21-COA-0038
224 E. Oak St.

Old Louisville Architectural Review Committee
Public Hearing

Bradley Fister, Historic Preservation Specialist
May 12, 2021

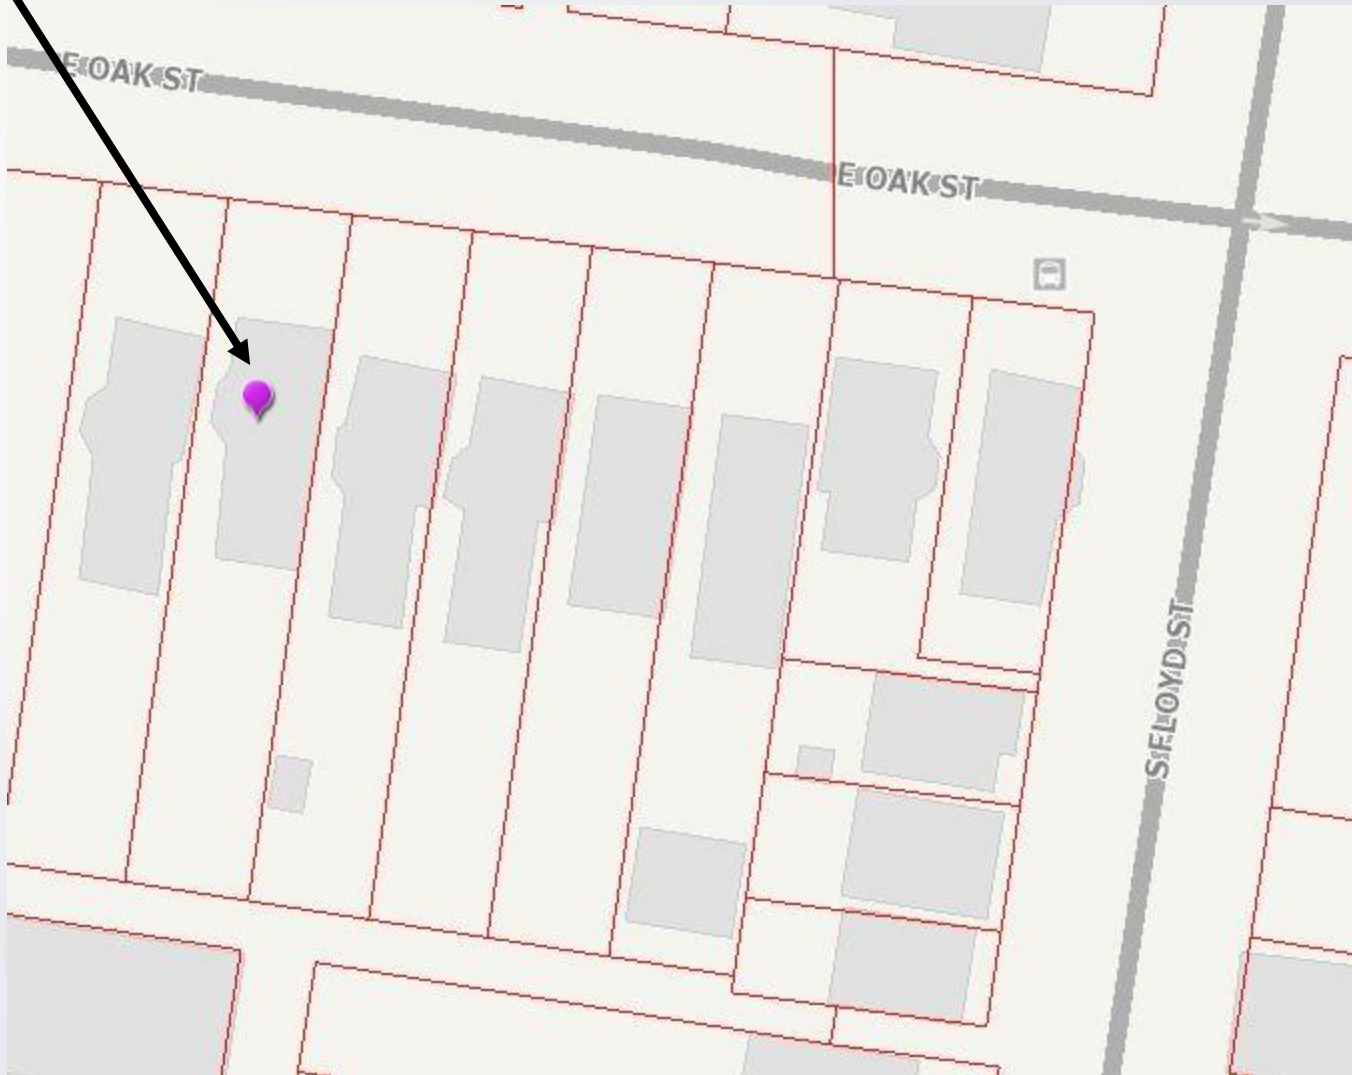
The applicant seeks approval for the proposed replacement of three one-over-one double-hung wood windows in a ganged configuration, with vinyl replacement windows. The existing transoms shall remain intact.
